CITY OF AMARILLO, TEXAS

DOWNTOWN URBAN DESIGN REVIEW BOARD

NOTICE OF PUBLIC MEETING

Project Information: COA-17-38, 2018 DDRB Hearing (3/1/2018)

PARTIAL DEVELOPMENT SERVICES SITE PLAN - B / PHASE I
 1/2" = 1'-0" SCALE

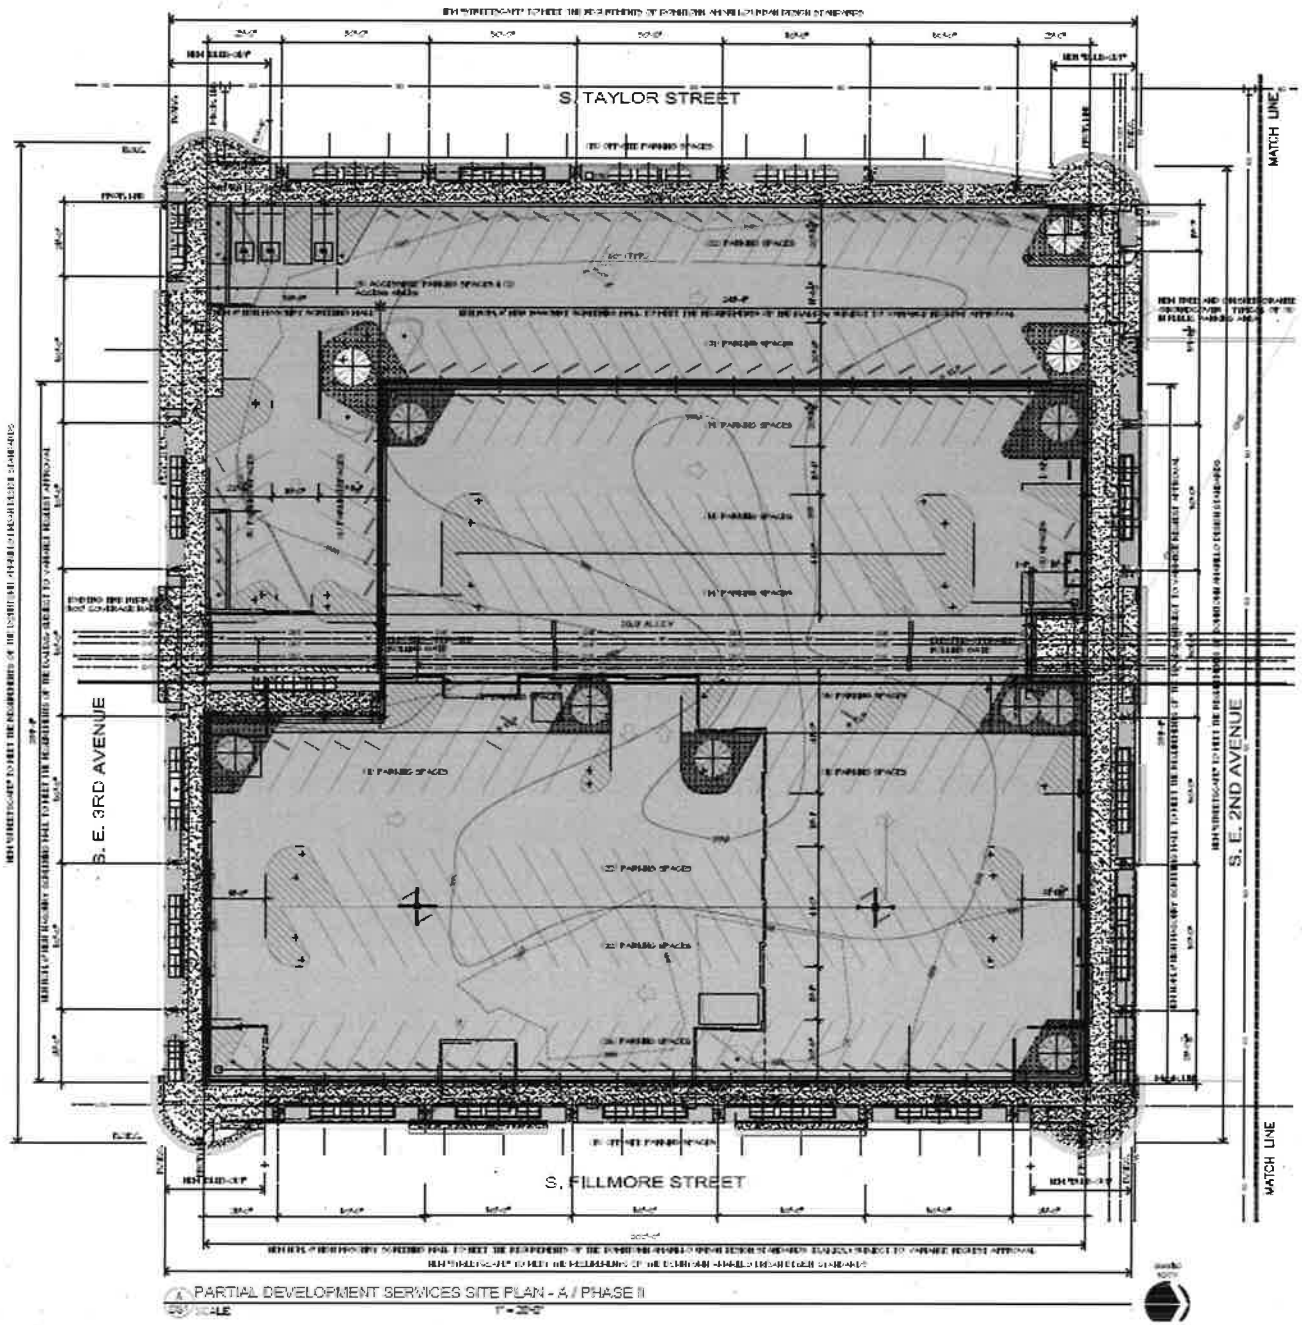
trees. Drip irrigation will be provided for planting areas. All street trees meet standards, except for the north site along South Taylor Street with a shorter width sidewalk not leaving enough room for street lighting and street trees. As such, **the applicant has requested a variance** from this standard set out in the DAUDS, which is addressed in the Variances section below.

- A 7' (minimum) unobstructed pedestrian pathway is required.
 - The site plan submitted for this project indicates a proposed 5' unobstructed sidewalk, 2' less than the minimum width required. The proposal of 5' is because the applicant is working in a tight space between TxDOT right-of-way for an overpass for South Taylor Street and following the city's driveway and parking standard manual for the parking lot. As such, **the applicant has requested a variance** from this standard set out in the DAUDS, which is addressed in the Variances section below.

- A portion (north site) of the proposed site plan shows no pedestrian lighting, and therefore does not meet any of the pedestrian lighting standards. The applicant has no room to place lighting on such a thin sidewalk as seen above, leaving all 5' for pedestrian access. As such, **the applicant has requested a variance** from this standard set out in the DAUDS, which is addressed in the Variances section below.

- Proposal: There are two existing parking lots which are adjacent to the pedestrian walkway along South Taylor Street; the first parking lot (south site), which encompasses the entire block north of the APD headquarters, proposes a 6' high CMU block wall for the protection of Police vehicles that has 0% transparency with 6'4" tall columns spaced every 20' apart. The second parking lot (north site), which is north across SE 2nd Avenue from the south site, proposes the same CMU block wall that also has 0% transparency. As such, **the applicant has requested a variance**, which is addressed in the Variances section below.

In light of the previous discussion and past approvals by the DDRB, considering the police department/security nature and behavior of this facility, and also taking into account the location of this site slightly outside the typical downtown development pattern (more industrial/warehouse area) **staff recommends approval of the item as presented along with variances 1 - 4.**

PARTIAL DEVELOPMENT SERVICES SITE PLAN - 4 / PHASE II
 SCALE 1" = 20'

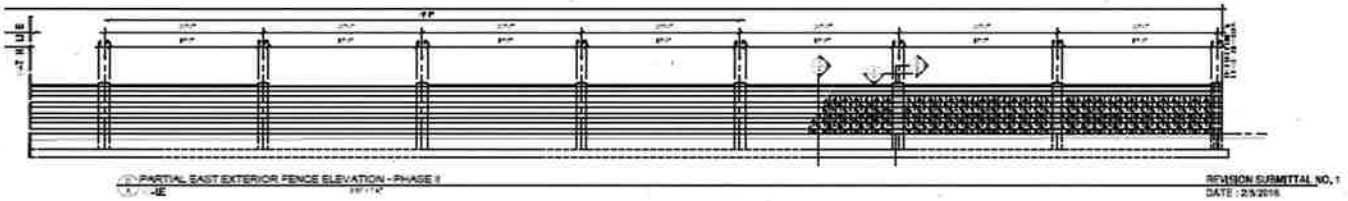
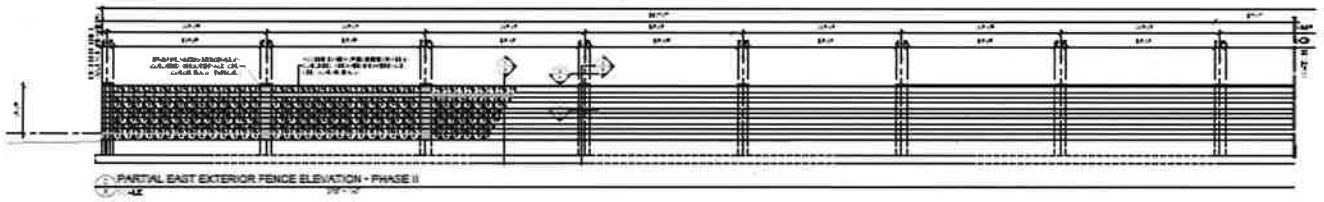
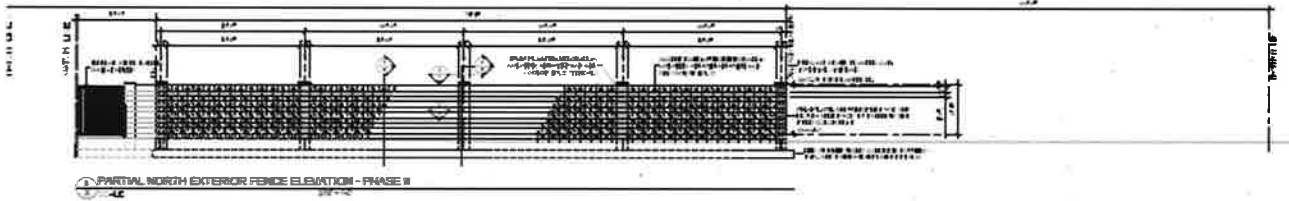
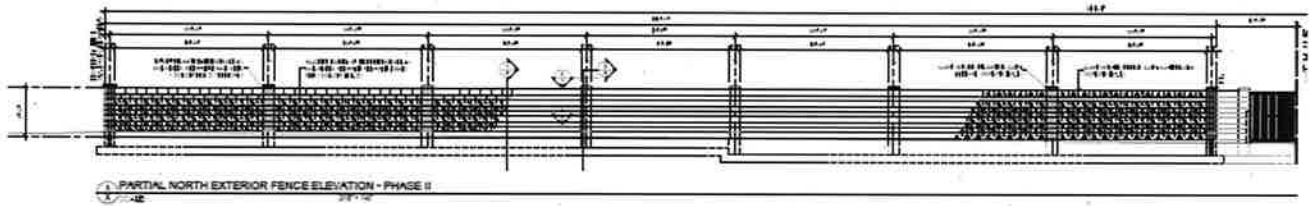
Variance 4: A complete variance from the 75% fence transparency, to allow a 0% fence transparency on the parts of the developments on the both north and south sites.

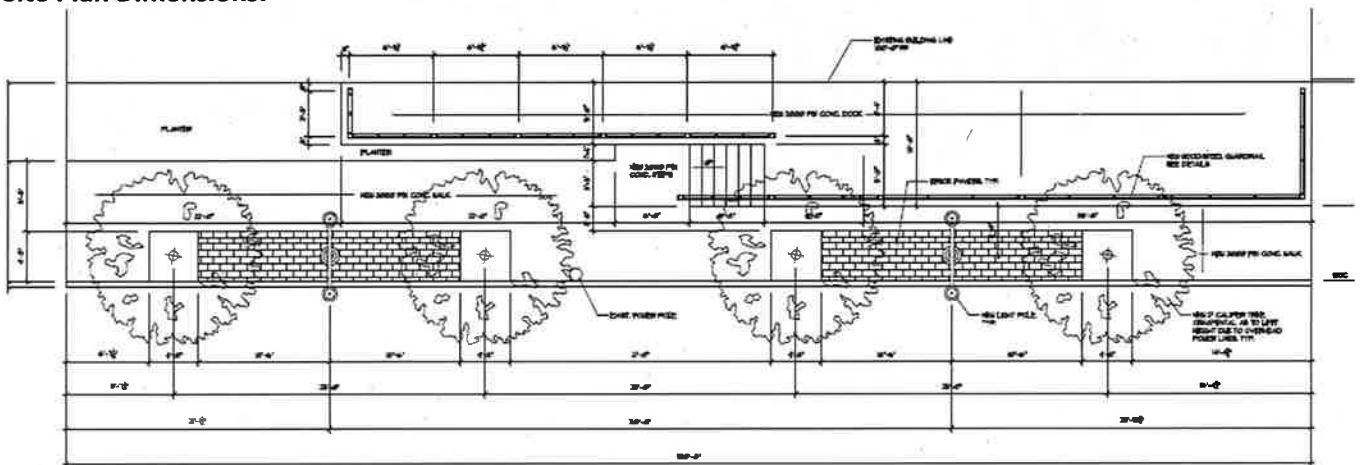
- A 7' (minimum) unobstructed pedestrian pathway is required.
 - The site plan submitted for this project indicates a proposed 4' unobstructed sidewalk, 3' less than the minimum width required. The proposal of 4' is because the applicant is working in a tight space between the right-of-way and an existing loading dock on the building that will be converted to a porch. This porch is higher than regular elevation, thus will require stairs and ADA ramp to access the inside of the building which will reduce the 7' into a 6' wide sidewalk area. Out of the 6', 2' is the furnishing zone and only 4' is unobstructed with no street lights or street trees hindering the pathway and meeting ADA requirements. The proposed stairs/ramp and porch are all located within their property and do not encroach into the public Right-of-way (ROW). This proposed porch is to be located in what use to be ROW that vacated 14.6' by 300' back in 1992 (V-92-10, Ord No. 5968). Thus leaving very little room for DAUD standard sidewalk and their building's access. As such, **the applicant has requested a variance** from this standard set out in the DAUDS, which is addressed in the Variances section below.

Variance 1: A 3' variance from the 7' minimum sidewalk widths to allow 4' unobstructed sidewalks along South Grant Street.

In light of the previous discussion and past approvals by the DDRB, and also taking into account the location of this site slightly outside the typical downtown development pattern (more industrial/warehouse area) **staff recommends approval of the item as presented along with variance 1.**
